NPS Detector Frame Mechanical Design and Constraints

(We are trying to “freeze” the outside
dimensions of the NPS detector frame)

Detector at 6 meters, 5.5 deg

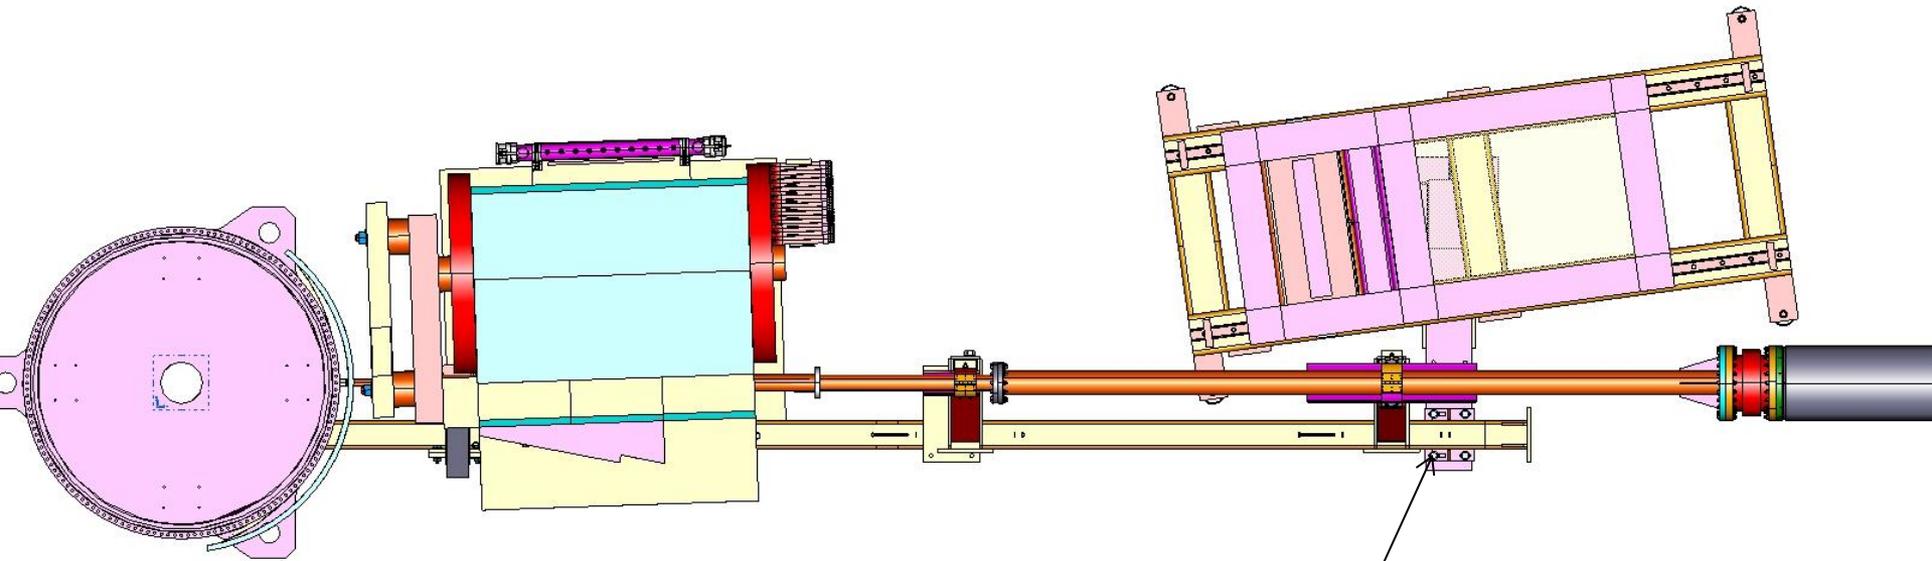
I tried to look at a table of angle and distances from the "designer's eye". Here are the cases we should check as far as I can judge:

5.5 degrees	6 meters
-------------	----------

7.9 degrees	4 meters
-------------	----------

Detector at 4 meters, 5.5 deg.

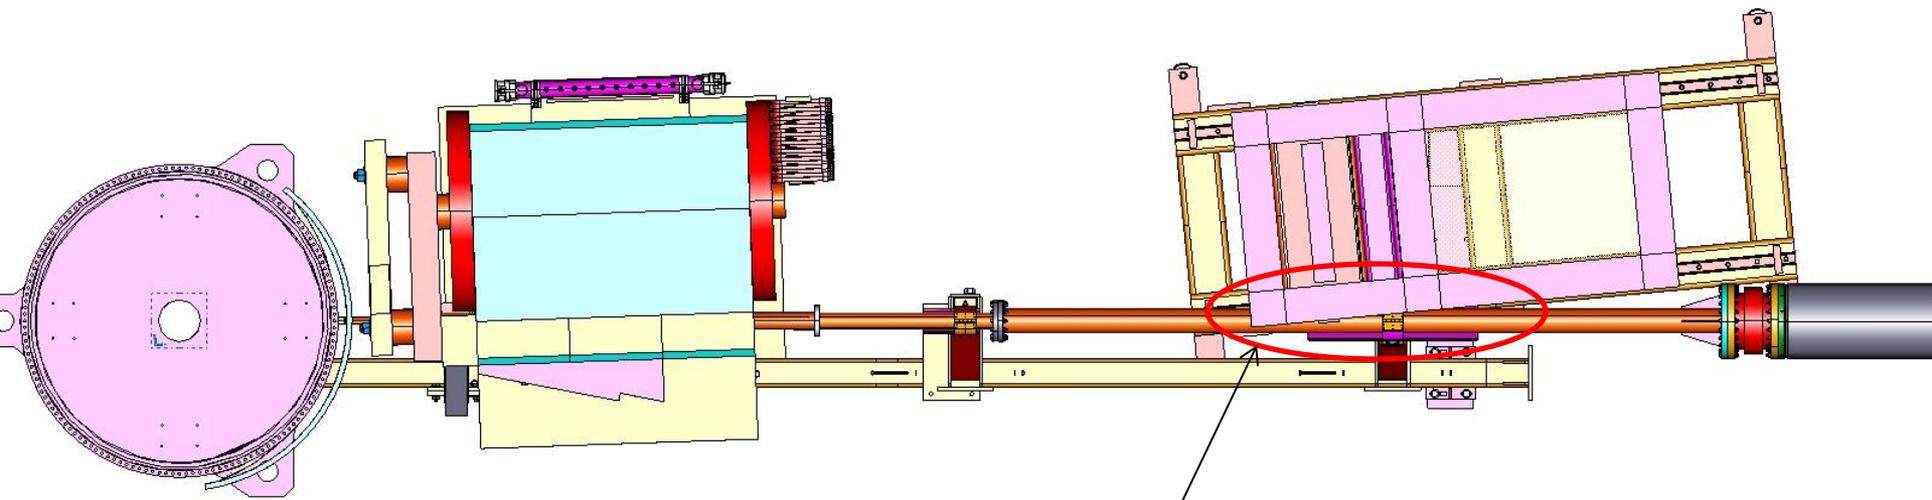
(at this distance it would also be good to check 5.5 degrees as this is our nominal "NPS facility design distance, so please see where the interferences are with 5.5 degrees and 4 meters too)

Interference with
beam line

New (shorter)
Beam line support

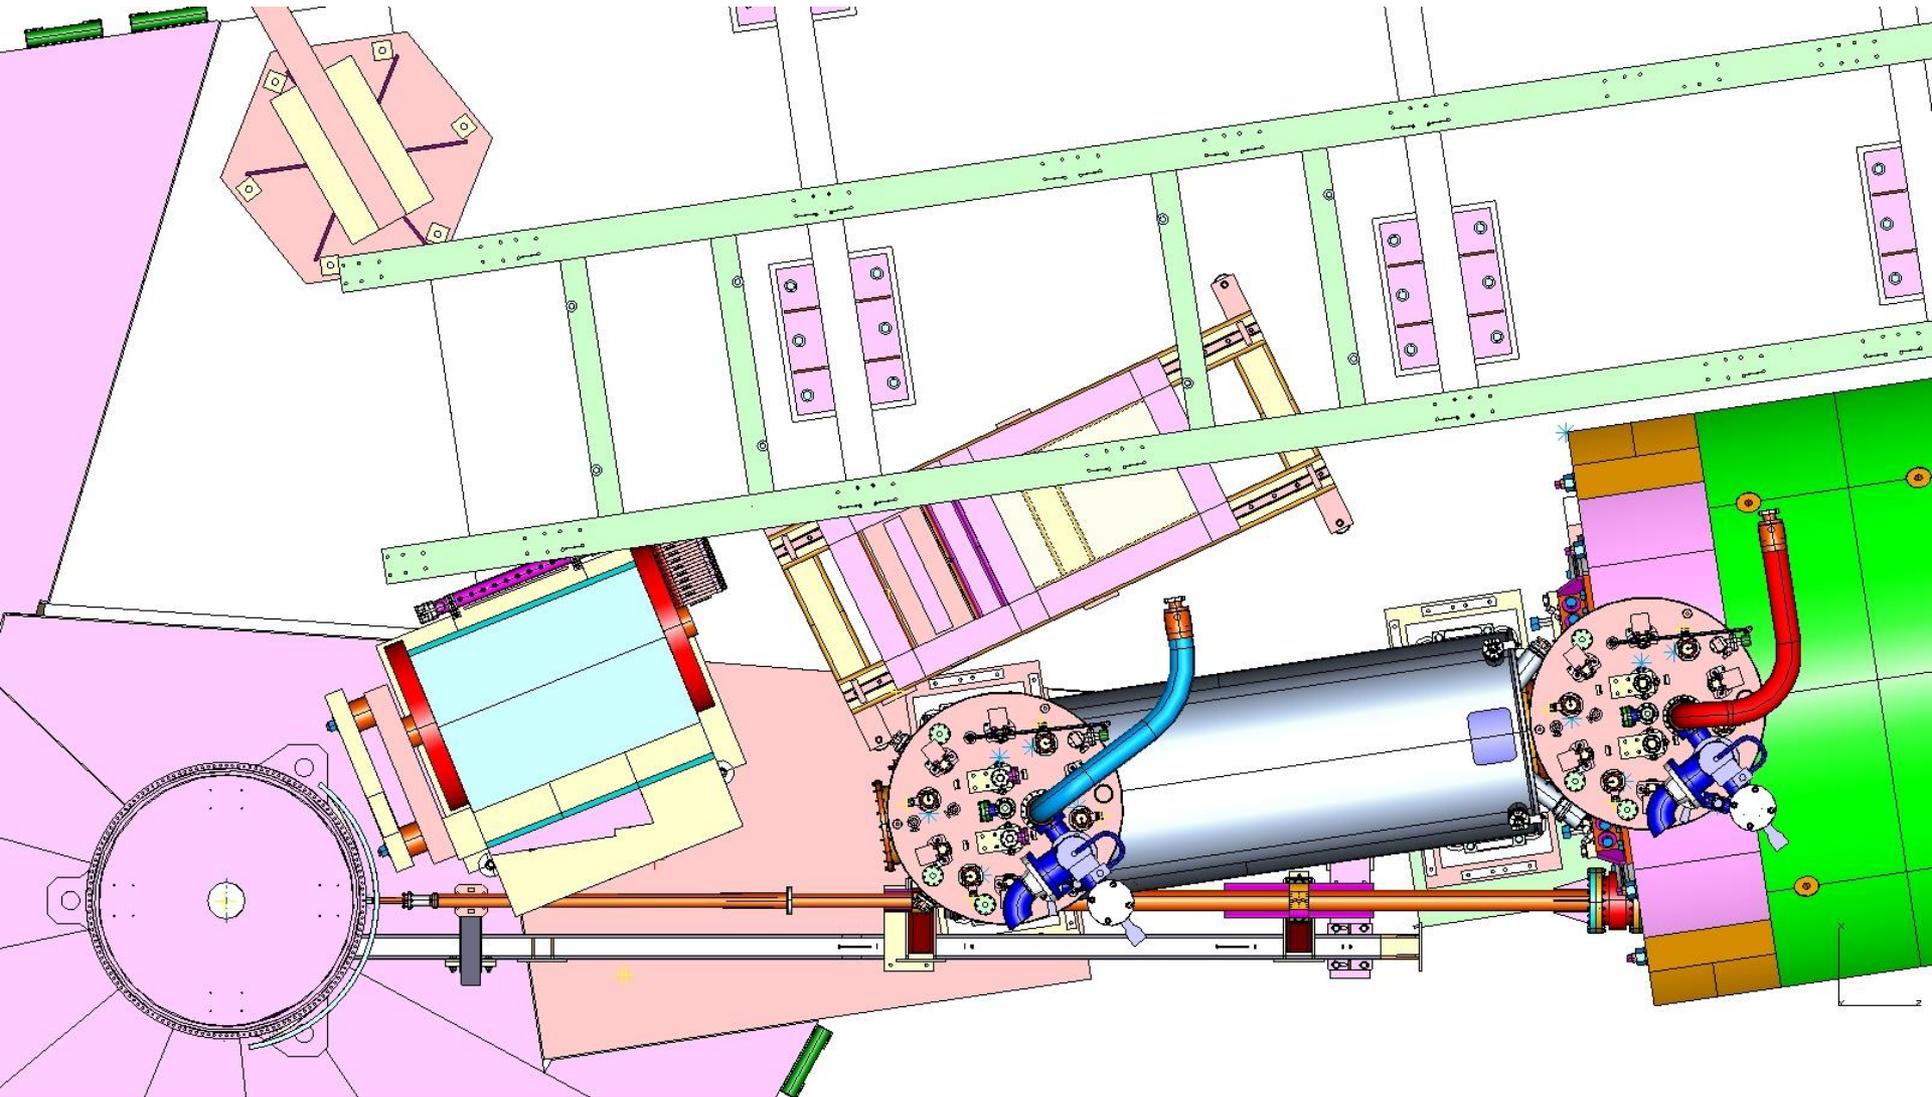
At NPS detector of 4 meters can make 6.5 degree fit easily

but would be very difficult to reach 6.0 degrees

In reality, at all these configurations the “2 degree scattering point” (this is the minimum angle accessible within the sweeper magnet gap when that magnet is positioned at a 5.5 degree central angle) is already well within the matrix of crystals, so it really does not help to push to smaller angles than 6.5 degrees for a detector distance of 4 m.

Question: Can we settle on 6.5 degree minimum angle for a detector distance of 4 meter?

Detector at 3 meters, 14.5 deg

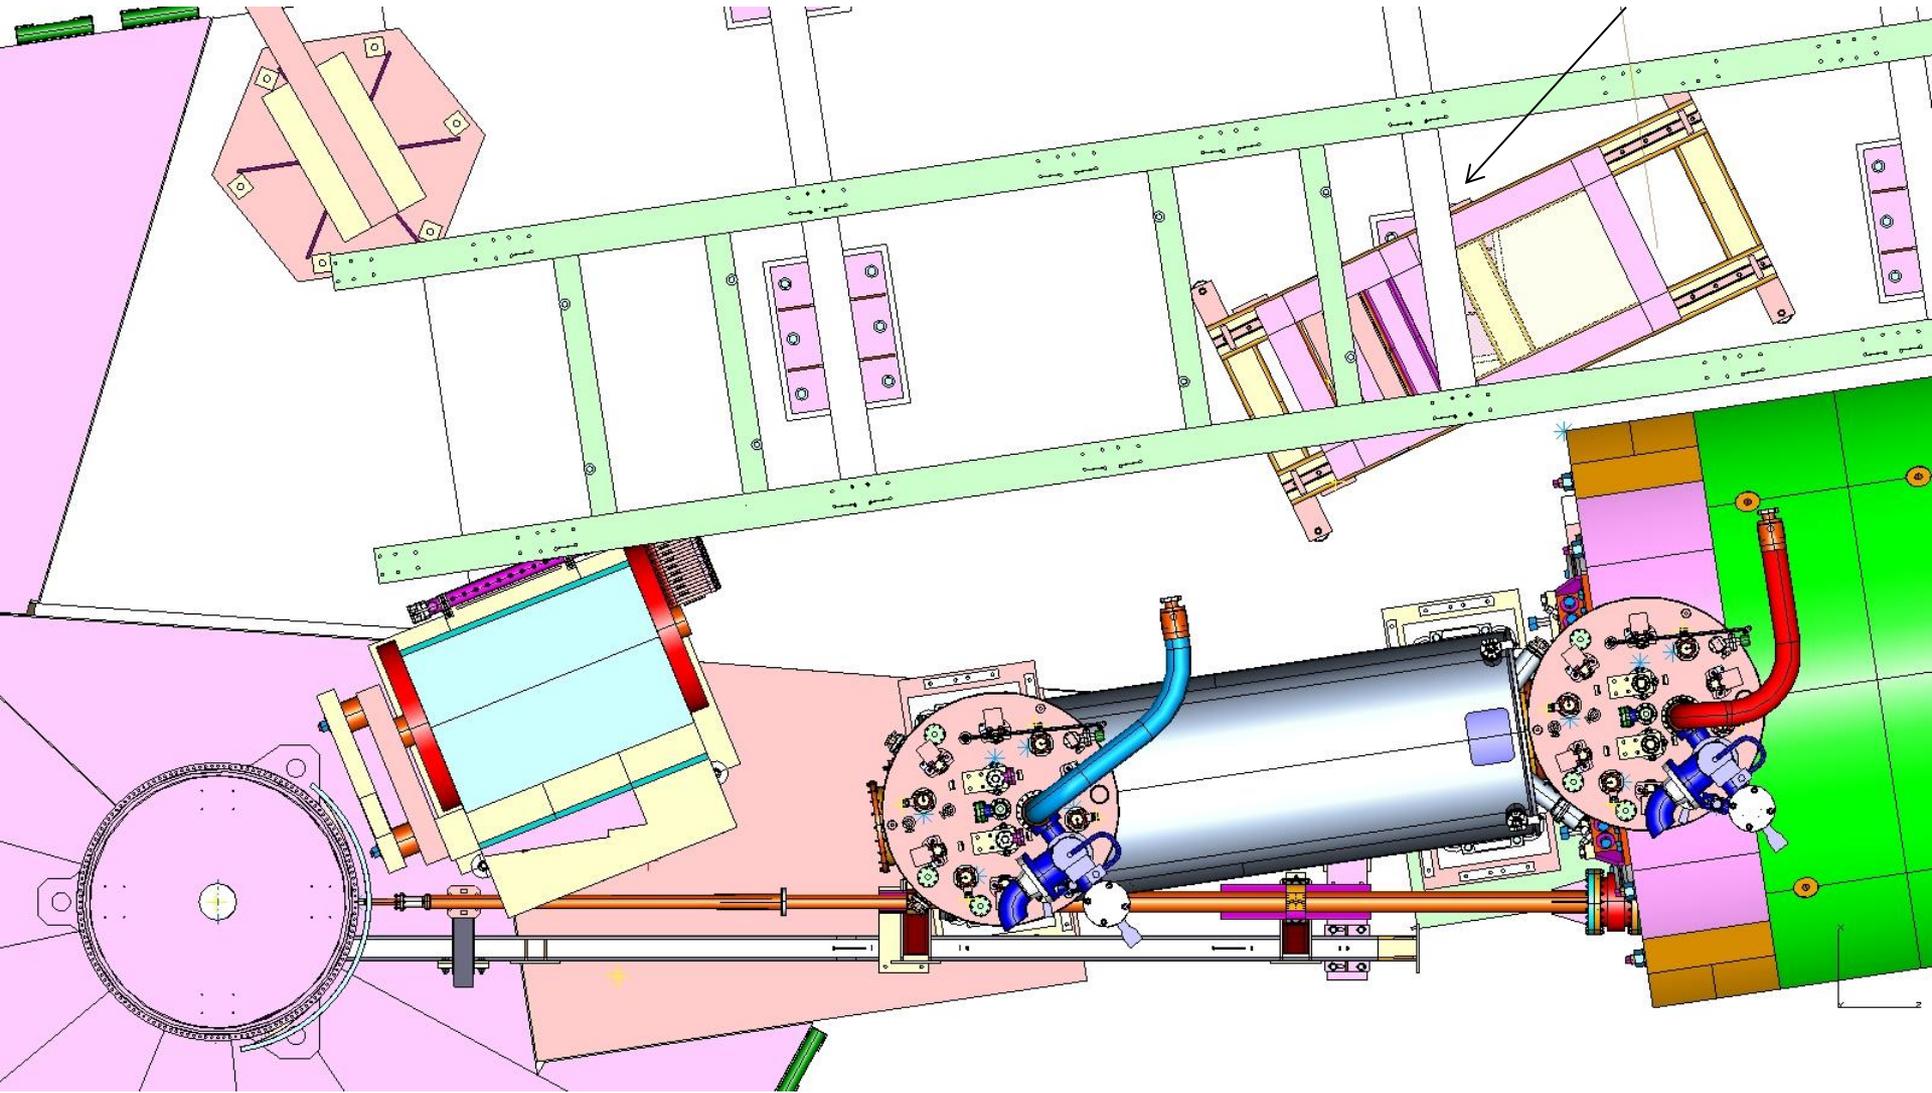
Relocate
support post

Originally thought this was all fine and asked Mike on the meeting of May 10th to only “tilt” the detector a bit more such that it would be able to slide through the first post and not hit the third one and we could potentially have a range of 3 meter to 6 meters...

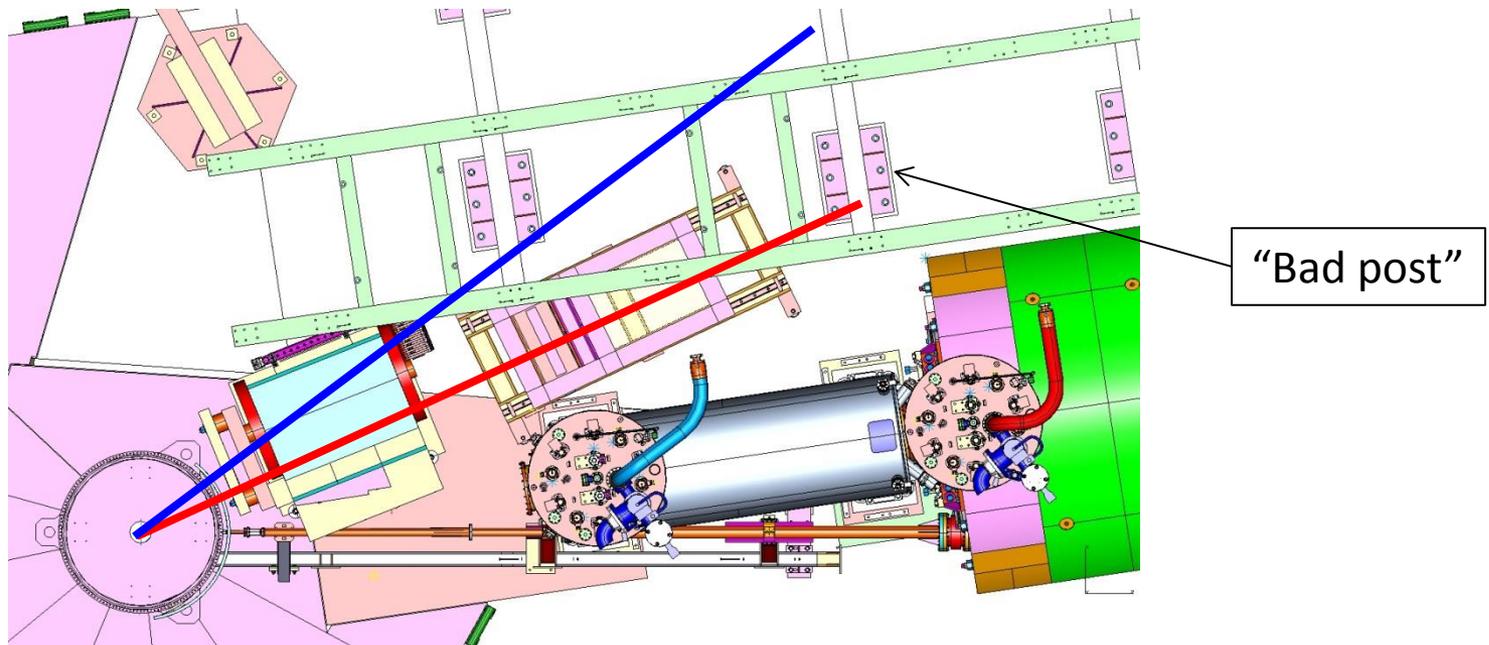
But: at walkthrough of Hall C found that the post that now would need to be removed to slide the detector from 3 meter to 5 meters has the run safe box and other electrical connections on it, and directly behind it the water (LCW) lines.

So, we should simply settle for less overlap with the small-angle configuration (i.e. ~20 degrees or more only) and go "outside" that post.
